AMDT. TO OL/CHANGE TO TECH SPEC CONSISTING OF APPLICATION SEEKING TO AMEND SEC. 3.1 7d IN APPENDIX A.

Re: Niagara Mohawk Power Corporation
Nine Mile Point Nuclear Station Unit No. 1
Docket No. 50-220

APPLICATION FOR AMENDMENT
TO
OPERATING LICENSE

Proposed Changes To Facility Operating License

Figure 3.1:7.f

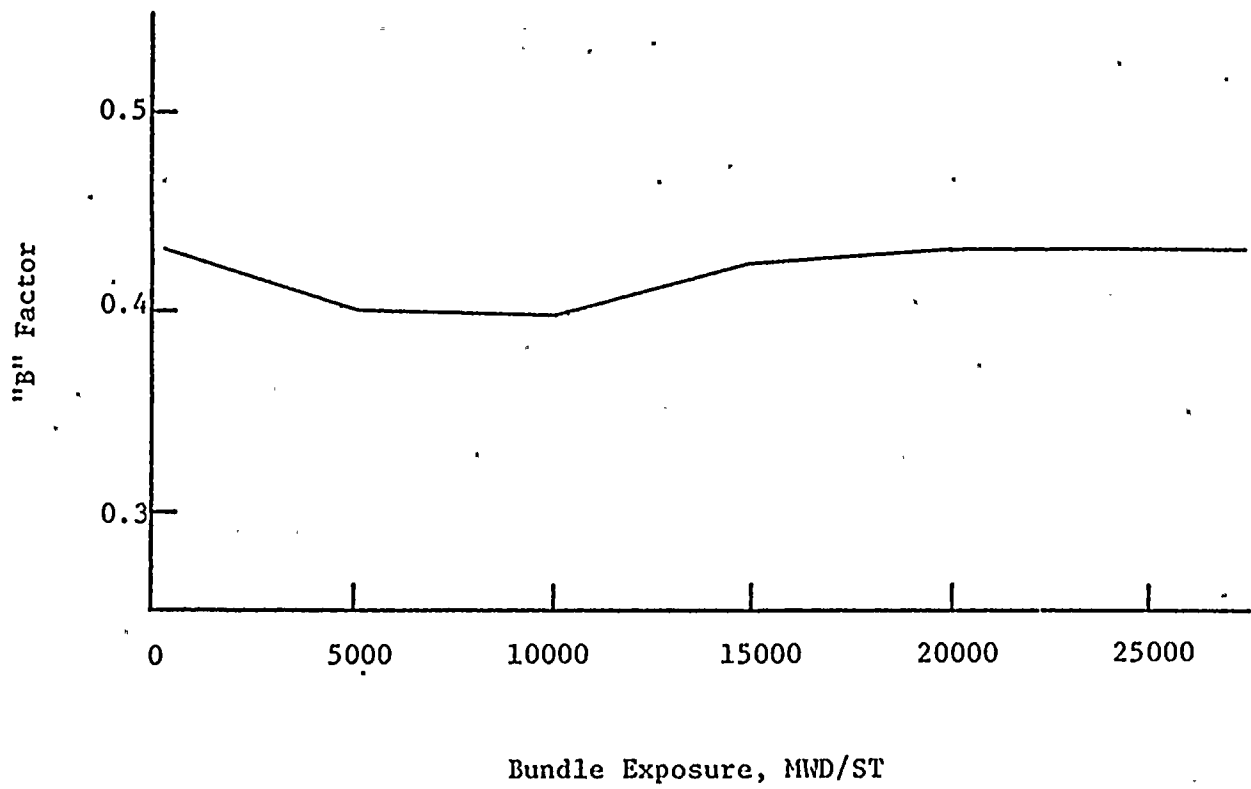
The present "B" factor calculations were based on constant dryout times for each of the 7 x 7 and 8 x 8 fuel types. Subsequent evaluations by General Electric, however, revealed that dryout times are exposure dependent. The re-calculated "B" factors, shown on pages 64c - 64e, reflect these variable dryout times.

It should be noted that the proposed limits are generally more restrictive for Fuel Types 1 and 3, and generally less restrictive for Types 2, 4, 5 and 6. Since Fuel Type 4 is currently limiting power output, the net effect of this change would permit a slight increase in power from the plant.

<u>Fuel Type(s)</u>	<u>"B"</u>
Type 1 - initial core	Figure 3.1.7.f
Type 2 - reload 1	Figure 3.1.7.g
Type 3 - reload 2	Figure 3.1.7.h
Type 4 - reload 3	Figure 3.1.7.i
Type 5 - reload 4 (2.50 enrichment) and reload 5	Figure 3.1.7.j
Type 6 - reload 4 (2.62 enrichment)	Figure 3.1.7.k
